Conceptual Review Agenda

Schedule for 04/06/15 to 04/06/15

Time	Project Name	Applicant Info	Project Description	Planner
9:30	East Ridge - Replat CDR150019	Craig Russell (970) 454-8855 crussell@russellmillsstudios.com	This is a request to replat portions of the previously approved East Ridge development plan. The new proposal calls for lot line adjustments for single family detached and additional conceptual plans for multi-family and single family attached units. The site is located in the Low Density Mixed Use Neighborhood (LMN) zone district. This proposal will be subject to Administrative (Type I) review.	Pete Wray

10:15	830 and 834 E Myrtle - Fourplexes CDR150020	Cynthia Reffler (970) 490-2962 cynthia@cjr-homes.com	This is a request to construct two fourplexes at 830 and 834 E Myrtle (parcel #'s 9713107017 and 9713107018). The existing structures on each lot will be removed. The proposed fourplexes will each be 3,600 square feet and two stories. The sites are located in the Neighborhood Conservation - Medium Density (NCM) zone district. This proposal will be subject to Planning & Zoning Board (Type II) review.	Clay Frickey

East Ridge - Description of Proposal:

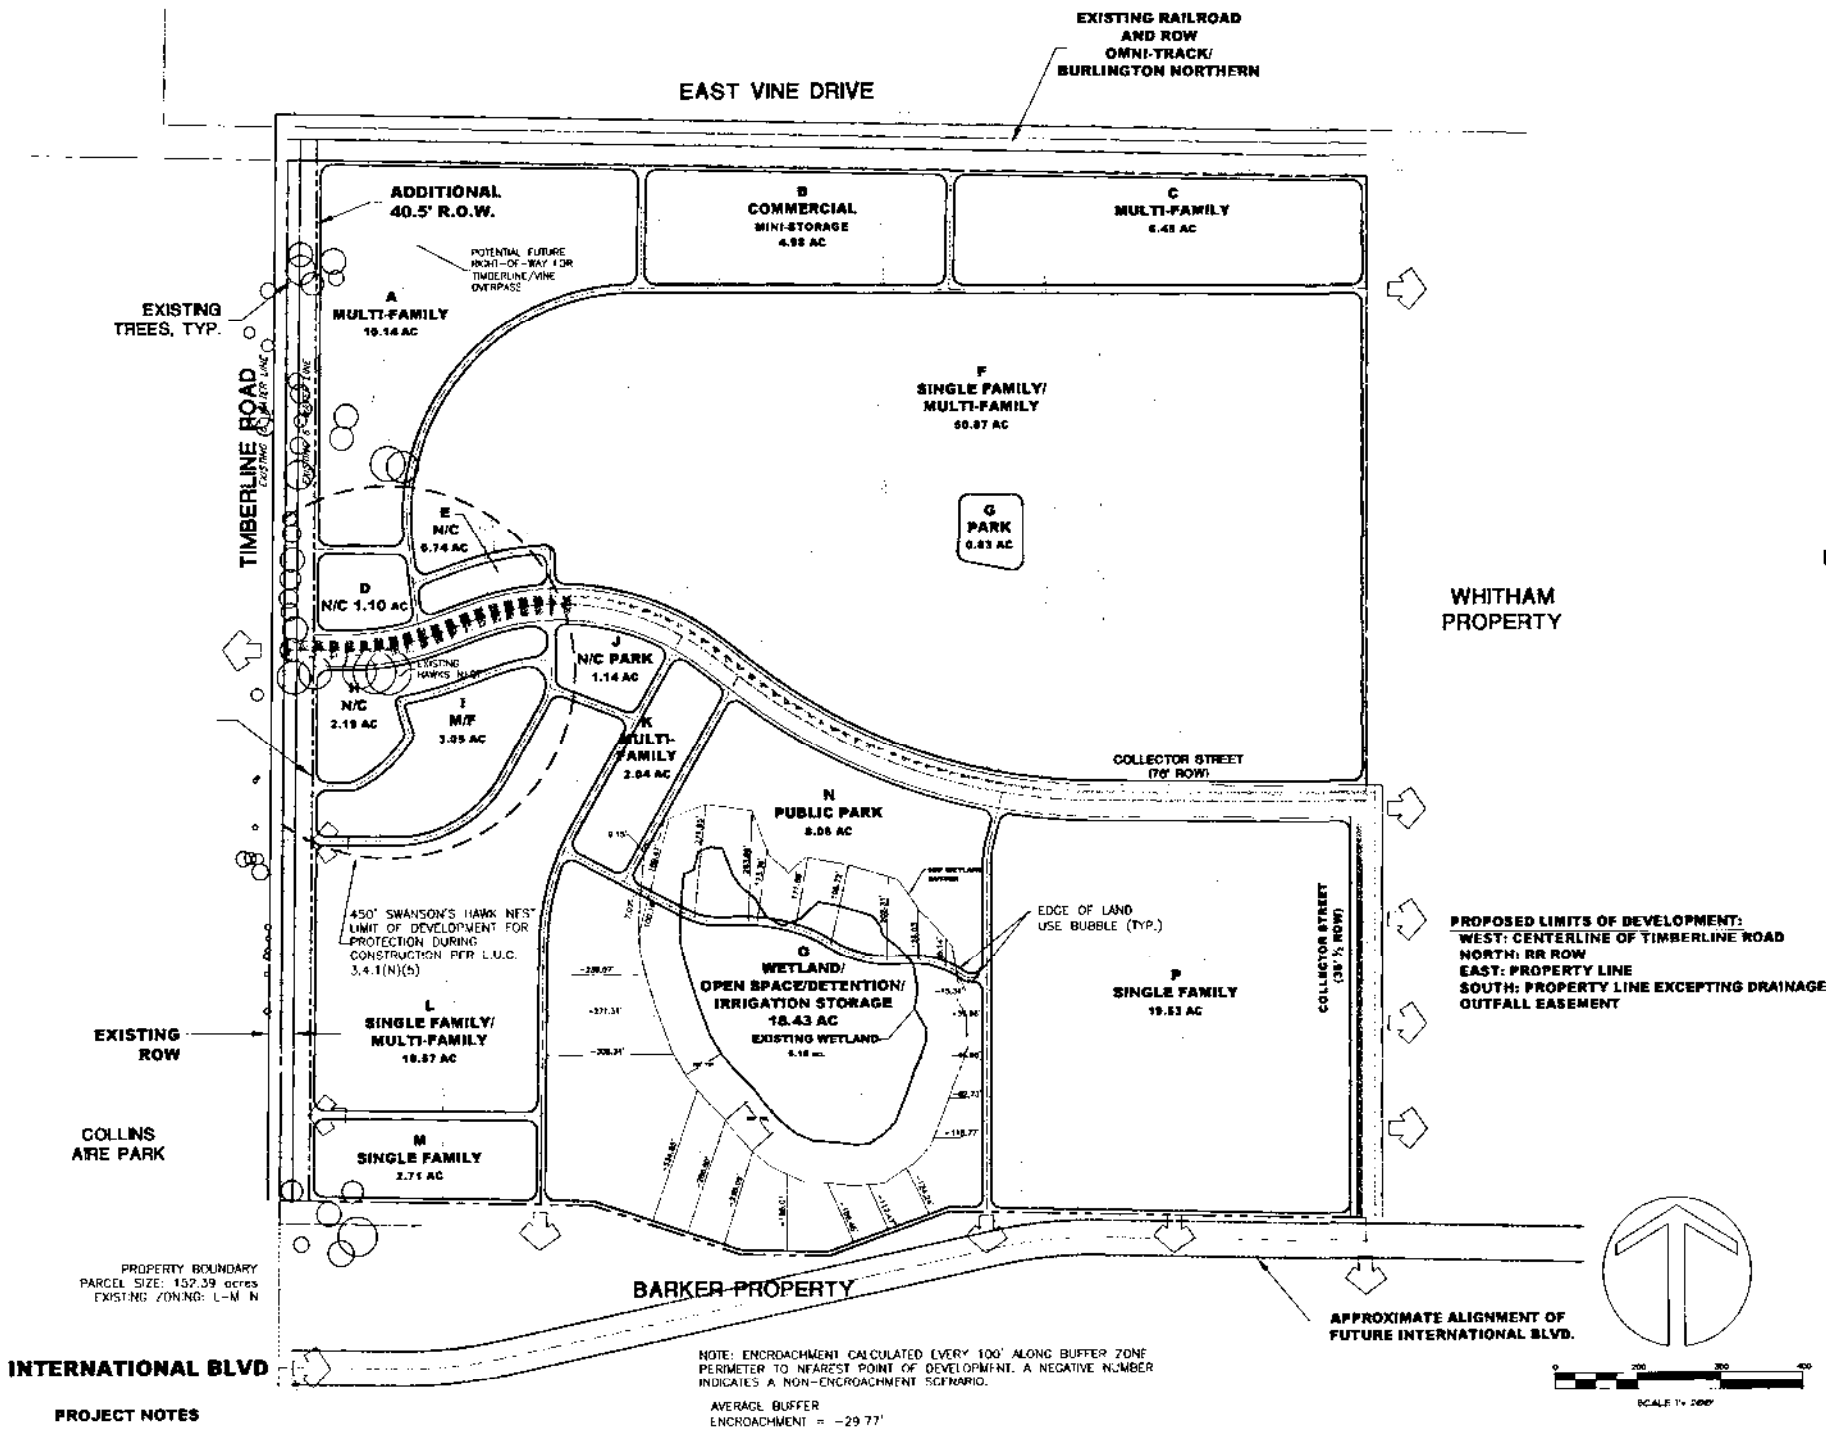
2. Regarding the accesses, what type of improvements are planning for the main entrance? Turn lanes? Also, the additional entrances shown further south may need to be restricted to right-in, right-out.

8. As has been discussed in prior meetings at the time that this project was originally approved Timberline Road was considered a 6 lane arterial road. Since that point in time it has been changed to a 4 lane arterial. The Timberline Road frontage along this development will need to be designed as a 4 lane arterial. The portion from the south property line to Sykes Drive will be built to this standard (curb, gutter, parkway, and sidewalk). Interim improvement will be needed from Sykes Drive north because the ultimate section cannot be constructed at this time. In order to provide for the developments local street obligation for this frontage a payment in lieu for the developers local street portion will need to be made prior to the issuance of a building permit in the development. The developer will be eligible for street oversizing reimbursement for the oversized portion of the street built to ultimate standards.

9. The driveway off of Zeppelin Drive looks too close to Timberline Road and doesn't look like it will meet separation standards. New Utility plans will be required and a new Development Agreement will be recorded once the project is finalized.

15. The plans need to accommodate any needed sight distance easements that are needed. The existing plat shows where existing platted sight distance easements are based on the intersections shown on that document. Need to make sure these are looked at as they will impact some of the lots and/ or structures shown.

SITE-PLAN

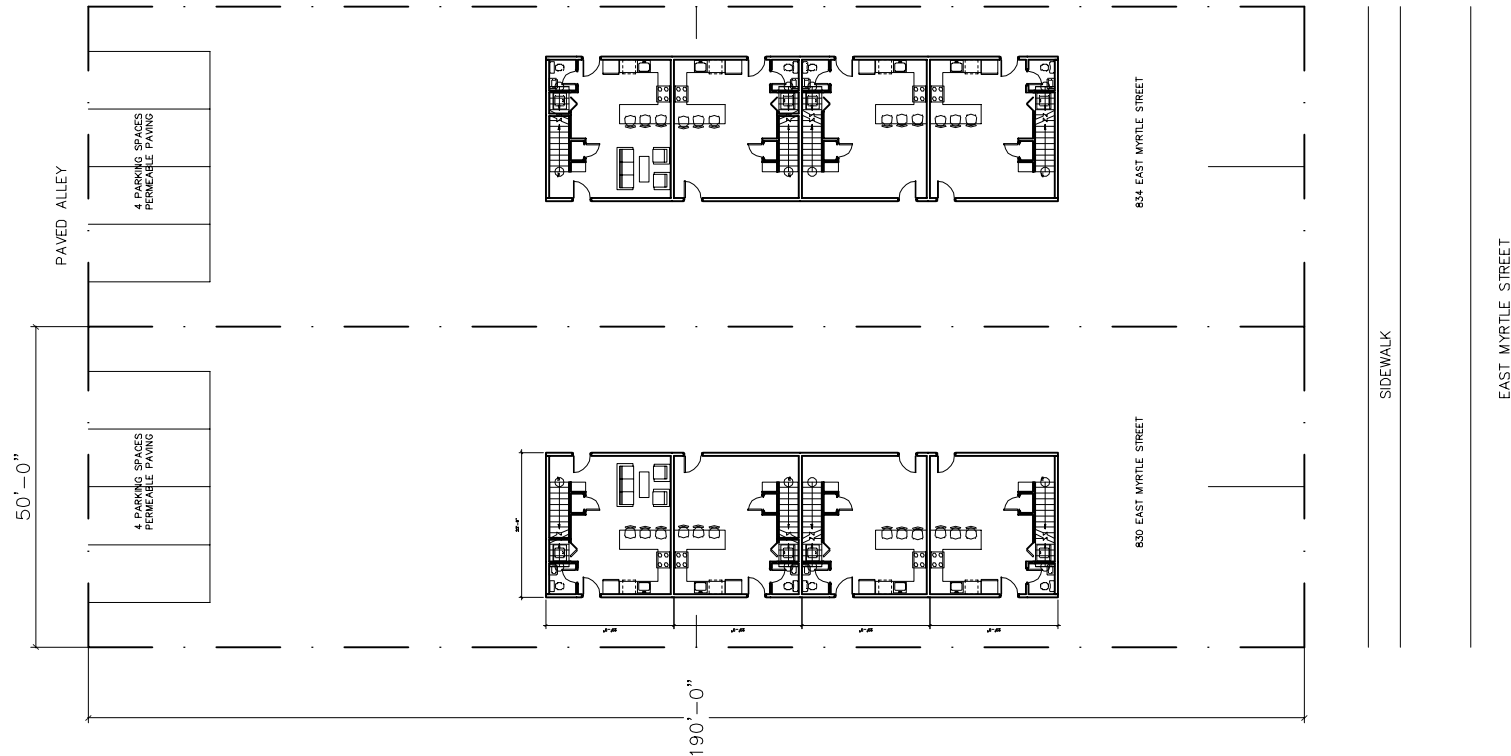
1. If I'm not mistaken there are four (4) duplexes with two on each lot according to the first site plan. There is not enough lot area to support this arrangement. A minimum of 10,000 would be required of each lot without a modification. On the second site plan there would be enough lot area.

4. In regard to both site plans presented there is an overall Floor Area Ratio (FAR) required meaning no more than 40% of the entire lot area can be taken up with floor area of both principal and accessory buildings. There is also a rear half FAR required meaning that on the rear 50% of the lot the floor area for principal and accessory buildings is limited to no more than more than 33% (of that rear half). See LUC 4.8(D)(2)(a)(2) and LUC 4.8(D)(3).
